UNITED STATES PATENT AND TRADEMARK OFFICE

Office Action Summary

09/890,143

DETAILED ACTION

FIG. 6(d)

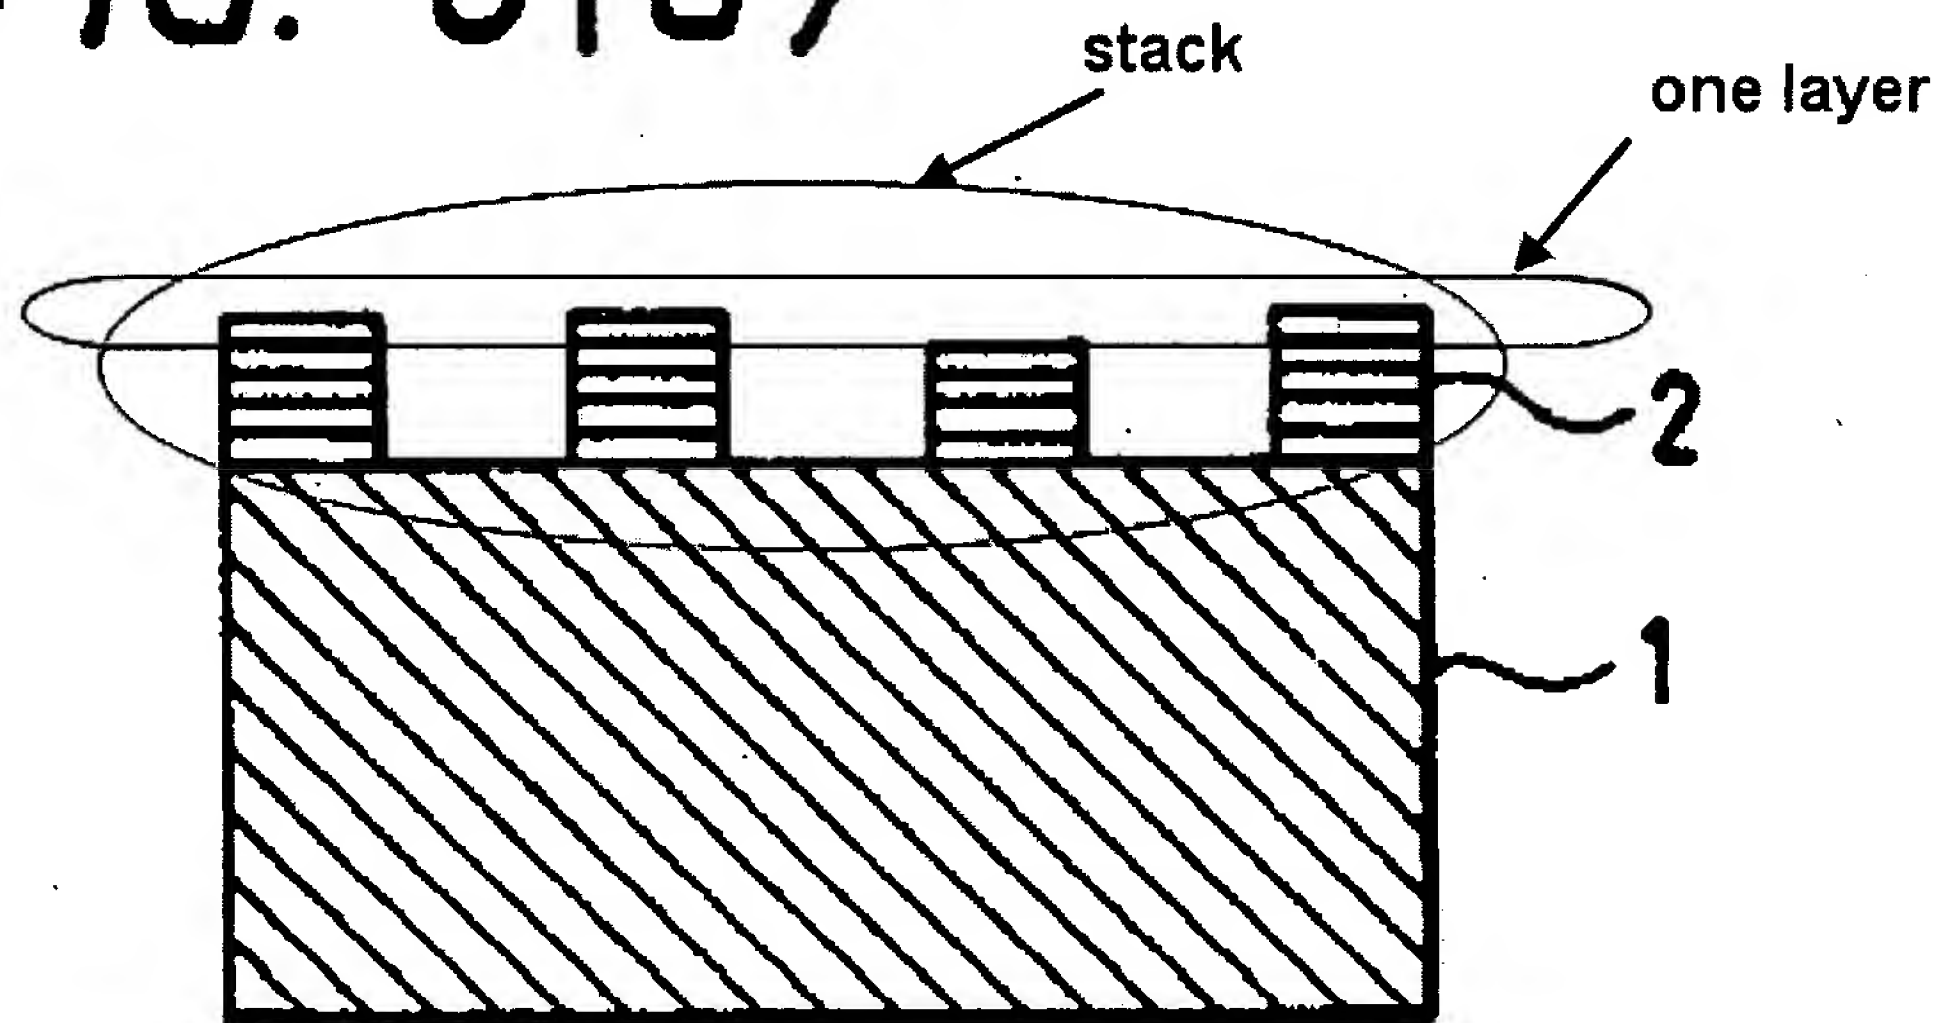
3. Regarding claims 31, 49, and 50, Itou et al. discloses a method comprising forming on a substrate (fig. 6d, #1) a multilayer film stack (fig. 6d, #2) of alternating layers of high refractive index material and low refractive index material (col. 5, lines 16-20), and cutting away a portion of the multilayer film stack (fig. 6c, #2) so that at least one layer successively arranged from an outermost surface of the multilayer film stack has a predetermined portion in which material of the respective layer does not exist (fig. 6c, #2) so that the respective layer is thereby non-uniform across the multilayer film stack (fig. 6d, #2), wherein the multilayer film stack, having said portion cut away, reflects radiation in a range from vacuum ultraviolet through X-ray (col. 1, lines 5-7), more than one alternating layer of high refractive index material and low refractive index material of the multilayer film stack (fig. 6d, #2), having said portion cut away, necessarily adjusts a wavefront phase of emerging rays, and said cutting away cuts away said portion in accordance with an amount of adjustment of the wavefront phase (col. 5, lines 37-46).

5. Regarding claim 38, Itou et al. discloses a multilayer film reflection mirror that reflects radiation in a range from vacuum ultraviolet through X-ray (col. 1, lines 5-7) comprising: a multilayer film (fig. 6d, #2) formed by a plurality of repeated pairs of layers, layers of each pair of layers having different refractive indexes from each other (col. 5, lines 16-20), at least one layer successively arranged from an outermost surface of the multilayer film having a predetermined portion in which material of the respective layer does not exist (via cutting in fig. 6c) so that the respective layer is thereby non-uniform across the multilayer film (fig. 6d, #2), and more than one pair of layers among said plurality of repeated pairs of layers necessarily adjusting a wavefront phase of a light reflected by said multilayer film (fig. 6d, #2).

7. Regarding claim 43, Itou et al. further discloses wherein said wavefront phase is adjusted with more than one layer among the pairs of layers where the reflectivity is already saturated (col. 5, lines 41-43) being partially removed (fig. 6d, #2).
